Dr. Stella Swanson
Chair, Joint Review Panel
Deep Geologic Repository Project

**Deep Geologic Repository Project for Low and Intermediate Level Waste –
Submission of Response to Information Request EIS-12a-512**

**OPG Response to Information Request EIS-12a-512
from Joint Review Panel**

Figure 1: Timeline for Project Implementation - Estimated Early Business Decision on Expansion Scenario

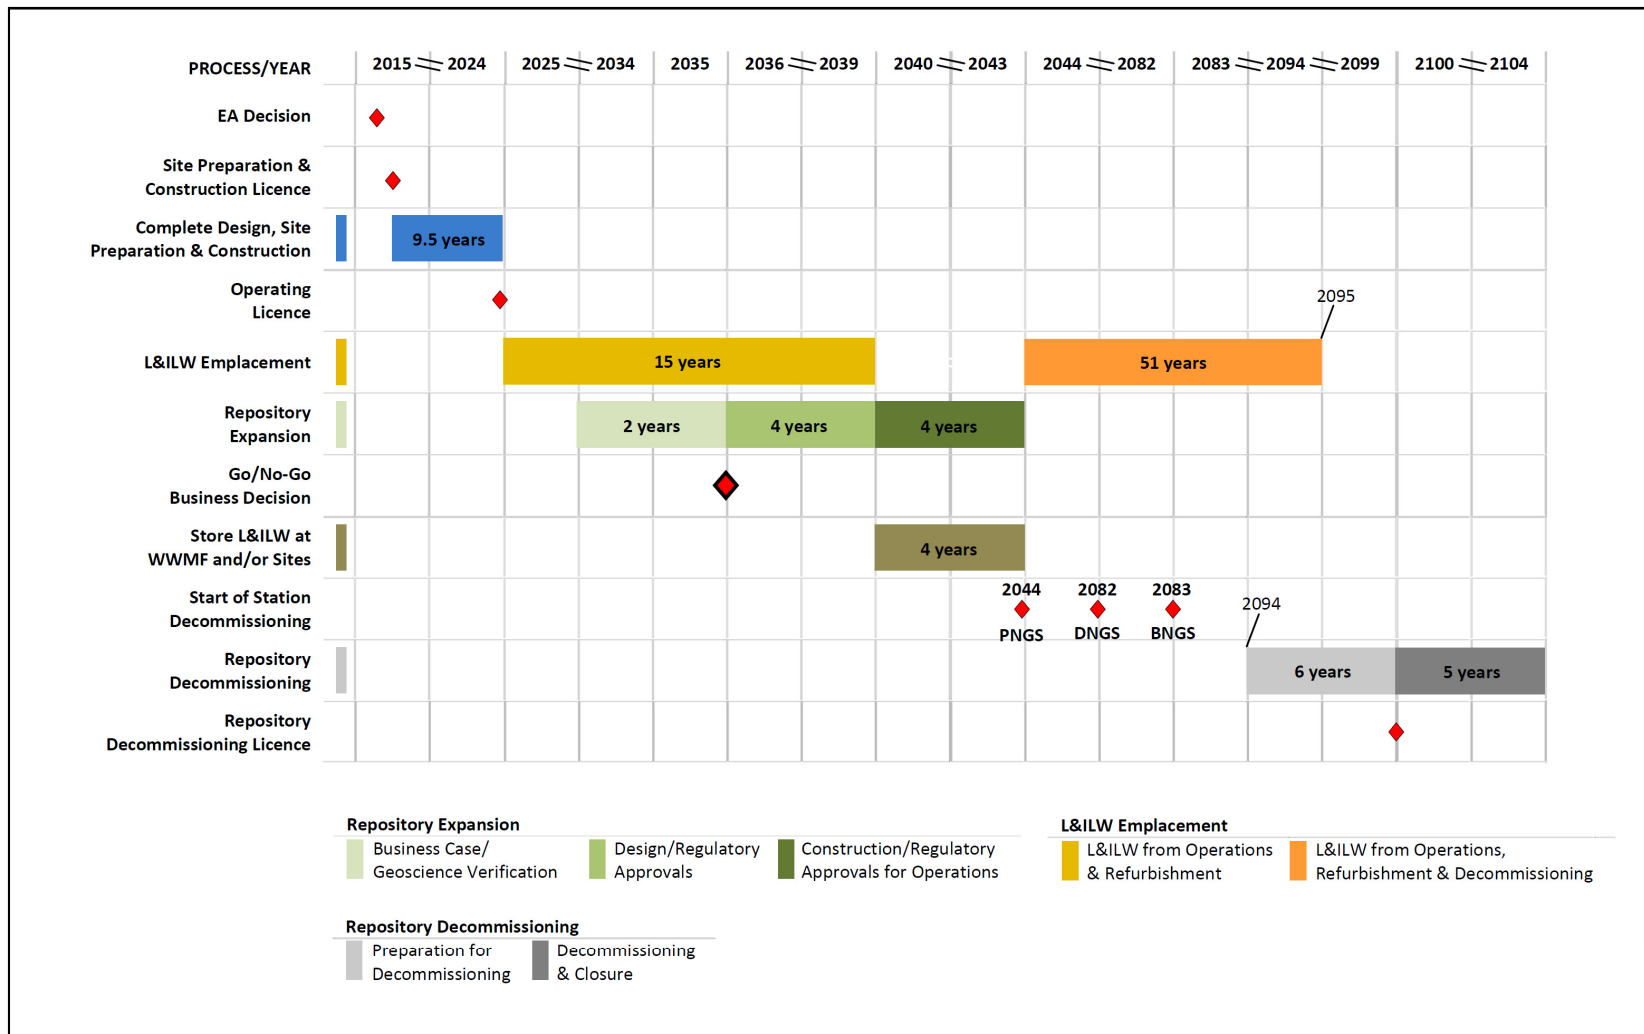
IR#	EIS Guidelines Section	Information Request and Response
EIS 12a-512	<ul style="list-style-type: none"> • Section 14, Cumulative Effects 	<p>Information Request:</p> <p>a) <i>Attachment A, Section 3 of the IR response relates only to waste conditions. Additional assessment of the impacts of extended operation of the repository on underground safety is required. OPG is to provide a discussion of excavation safety implications including the integrity of occupied excavations. For example, the expansion of the repository to accommodate decommissioning waste would extend the underground repository operational period which may impact the effectiveness of the planned support measures (such as rock bolts, shotcrete and other surface reinforcement tools) due to processes such as corrosion. Consideration of any changes to the frequency and extent of maintenance or replacement of support measures may also be required. Describe any underground safety-related strategies for possible future expansion that OPG has undertaken to incorporate during the initial development of the DGR. OPG referred to incorporating lessons learned from international waste repositories during the hearing (Transcript Volume 15: October 3, 2013, p. 177, l. 16), as well as in IR EIS-08-366 (“concurrent room excavation and waste emplacement, versus having these activities sequential is an important design and operational consideration”).</i></p> <p>b) <i>Provide further clarification regarding Short-Term and Long-Term Safety Implications of expanding the DGR.</i></p> <p><i>This information request arises from the need to determine whether factoring decommissioning waste into plans for the construction and the operation of the DGR would affect the current safety case (without decommissioning waste). Explain whether and how OPG would plan for and implement longer-term methods and measures to ensure underground safety, environmental protection, and safety of the public from the beginning of the project, illustrating a holistic understanding of the fundamental requirements for safety and environmental protection, should the project evolve.</i></p> <p><i>Examples of issues to consider during holistic planning (in addition to the two issues explicitly addressed below) include:</i></p> <ul style="list-style-type: none"> • <i>contingencies for unexpected variation in the lateral and vertical extent of the Cobourg Formation;</i> • <i>sequencing and configuration of emplacement rooms in order to optimize efficiency, safety and environmental protection (i.e., planning backwards from the inclusion of all decommissioning waste and looking for areas of risk that would require a new or enhanced mitigation approach, as well as opportunities for efficiency, such as in the timing of placement of certain types of waste);</i> • <i>the capacity that would ultimately be required for the stormwater management pond, and any associated impacts to wetlands; include consideration of handling and safe long-term disposal of solids from the bottom of the pond; and</i>

IR#	EIS Guidelines Section	Information Request and Response
		<p>Figure 1 illustrates an early scenario where an OPG decision to expand the DGR is made near the end of 2035. Assuming that it would take 4 years for the design/regulatory approvals process and 4 years for construction, the repository would be available to receive decommissioning L&ILW starting in 2044 which is the earliest start date for Pickering NGS decommissioning. In this scenario, decommissioning waste would not require sustained interim waste storage either at the reactor site or the Western Waste Management Facility.</p> <p>Figure 2 illustrates a late scenario where an OPG decision to expand the DGR is made in the 2060's at the end of the proposed DGR operations period. Before any work would begin on the decommissioning and closure of the DGR, OPG would consider various options for long-term management of decommissioning L&ILW and then make a decision on whether to send decommissioning wastes to the DGR. In this scenario, prior to the expansion of the DGR, Pickering decommissioning L&ILW would be placed in interim storage or alternative means for disposal identified.</p> <p>The two scenarios provided show that OPG has a broad range of time from the mid 2030's to the mid 2060's in which to make a business decision for the potential expansion to the DGR.</p> <p>Figure 3 shows the layout of the repository after expansion, as previously presented.</p> <p>Figures 4 and 5 provide illustrations for the sequencing for the above two expansion decision options. In all cases, the intent is to minimize the time that rooms remain open to avoid the need to replace ground support systems, and to isolate waste-filled emplacement rooms before expansion excavations begin. For illustrative purposes, construction periods are shown in green and operational periods shown in yellow.</p> <p>Figure 4 shows the possible sequencing of activities for the early scenario. Panel 2 is filled with operational and refurbishment L&ILW from the WWMF and isolated with closure walls. This timing corresponds with the planned timing for a business decision to expand the DGR. Waste placement ceases and Panels 3 and 4 are constructed. Upon re-initiation of waste placement following regulatory approval, L&ILW operational, refurbishment and decommissioning waste could be placed concurrently and not segregated to specific areas of the DGR where the waste type and packaging permits. The initial rooms of Panel 1 could remain available for rail-based wastes and the remainder of the repository filled to minimize the time emplacement rooms remain open (i.e. starting in Panel 1). Waste filled panels would be closed or isolated with closure walls following completion of emplacement within the panel. These considerations are illustrated in Figure 4, however, the final arrangement of emplacement would need to be reviewed as part of the expansion decision process.</p> <p>Figure 5 shows the sequencing for the late scenario. This option does not provide the opportunity for concurrent emplacement as the timing for the decision is not made until the proposed DGR is full of waste arising from operations and refurbishment. All waste filled panels would be isolated by closure walls prior to the initiation of construction. As with the proposed DGR, following construction, the waste arising from decommissioning would fill from the farthest rooms and work back towards the shafts, with closure walls following panel completion.</p>
